CALL NO. 109
CONTRACT ID NO. 131218
ADDENDUM # 1

Subject: Hart County, NHPP IM 0652 (089)
Letting November 22, 2013

- (1) Revised - Plan Sheets
- (2) Added - Special Notes - Pages 17(a)-17(i) of 224
- (3) Added - Traffic Loops - Pages 17(j)-17(rr) of 224
- (4) Revised - Bid Items - Pages 216-224 of 224

I-65 WIDENING & OVERLAY

TYPICAL SECTIONS- I-65

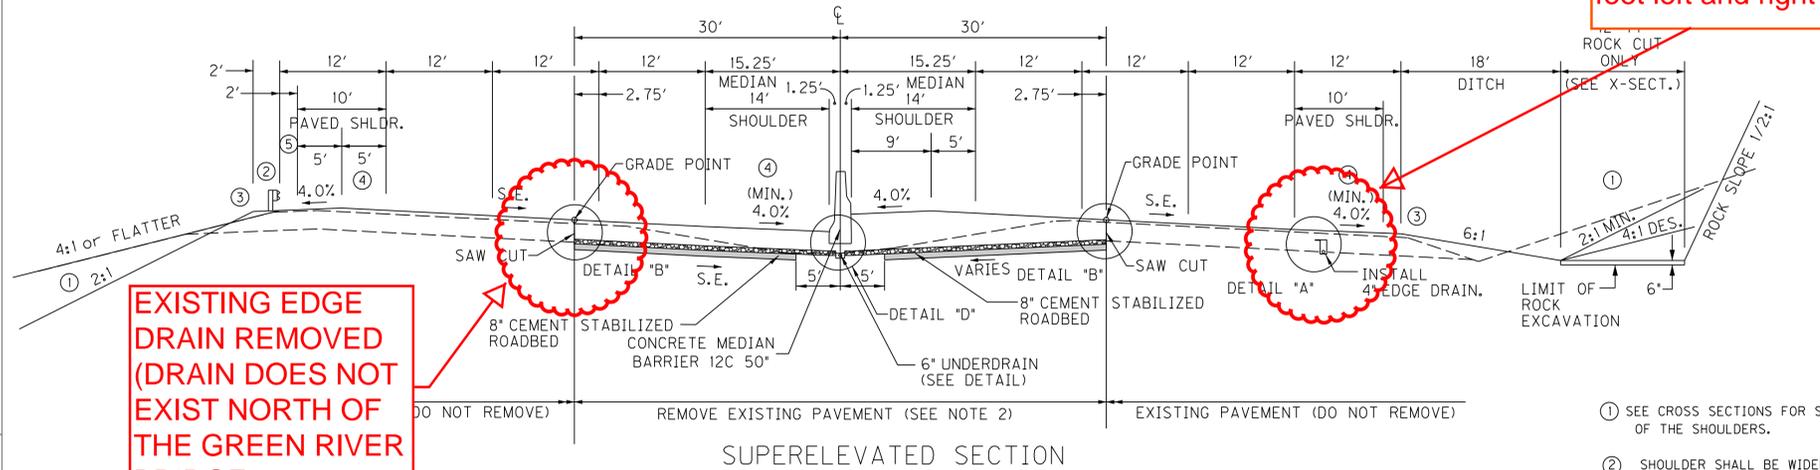
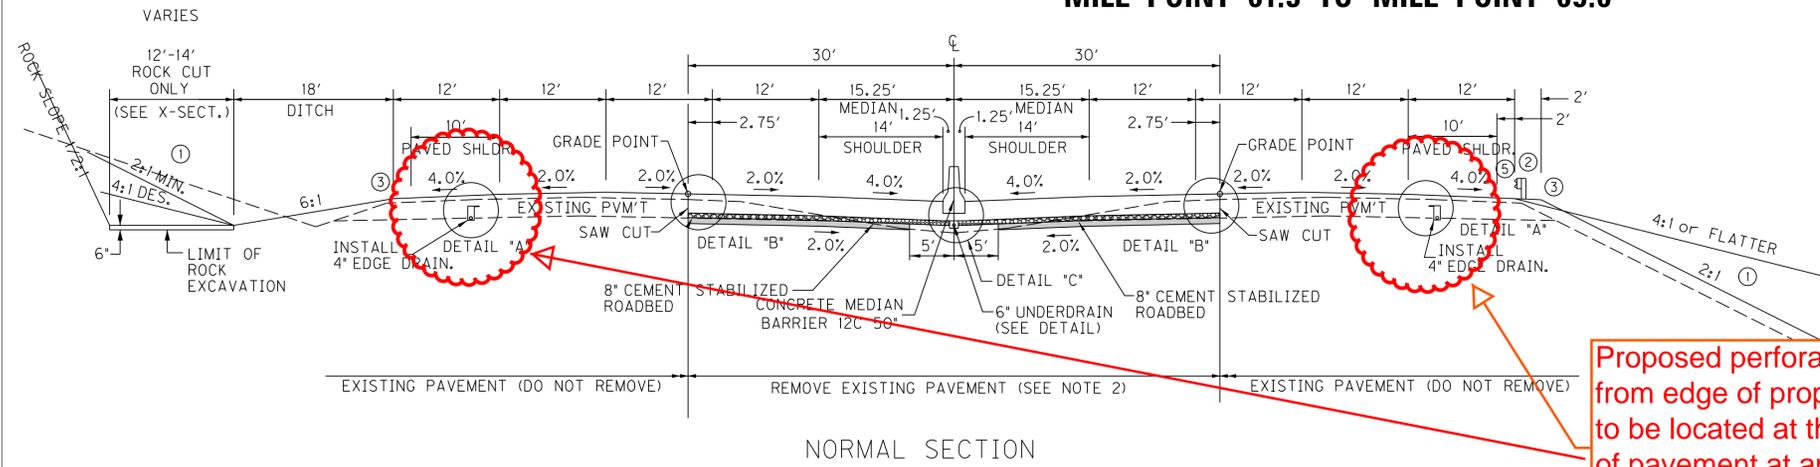
Proposed perforated pipe moved from edge of proposed shoulder to be located at the existing edge of pavement at approximately 54 feet left and right of centerline

EXISTING EDGE DRAIN REMOVED (DRAIN DOES NOT EXIST NORTH OF THE GREEN RIVER BRIDGE)

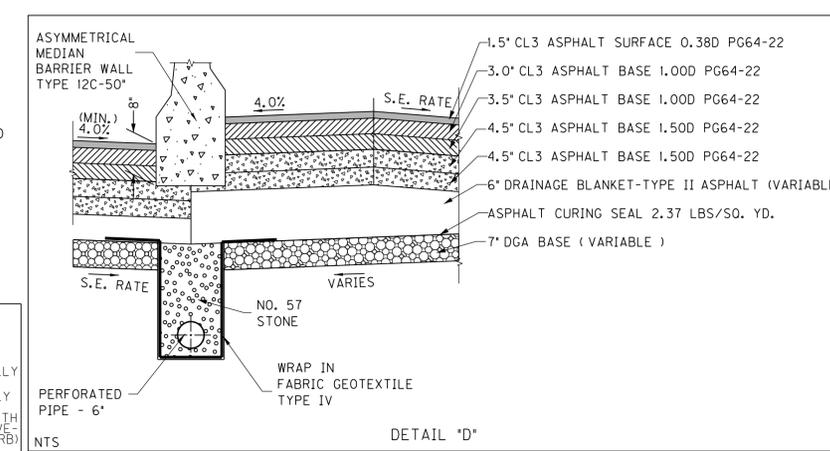
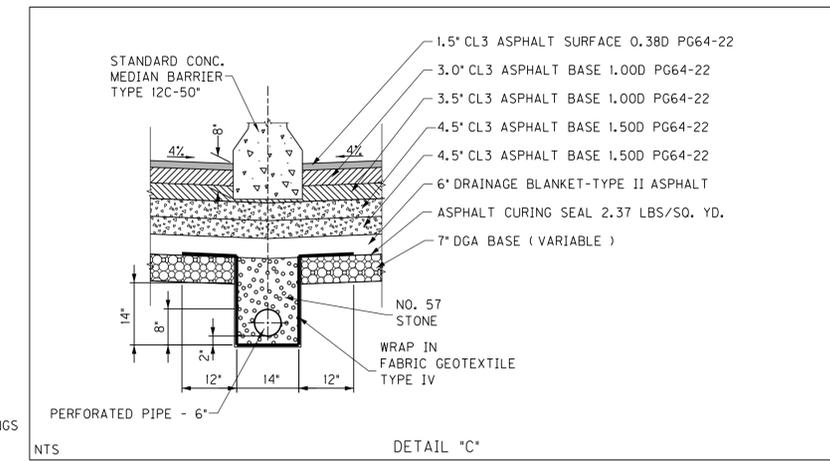
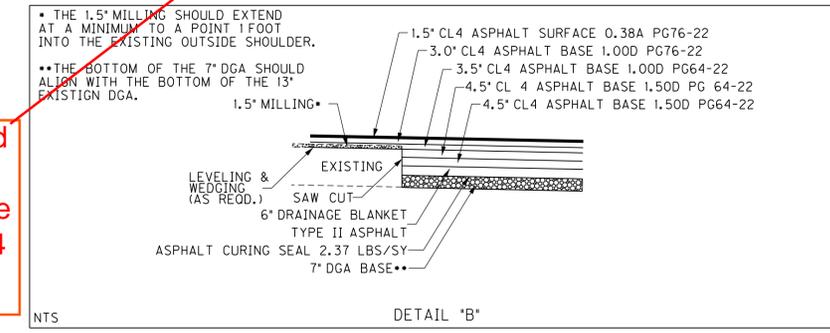
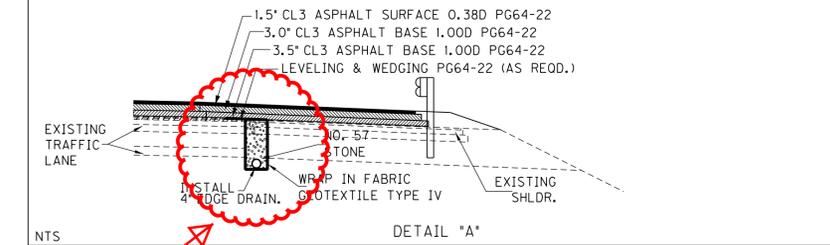
Updated detail
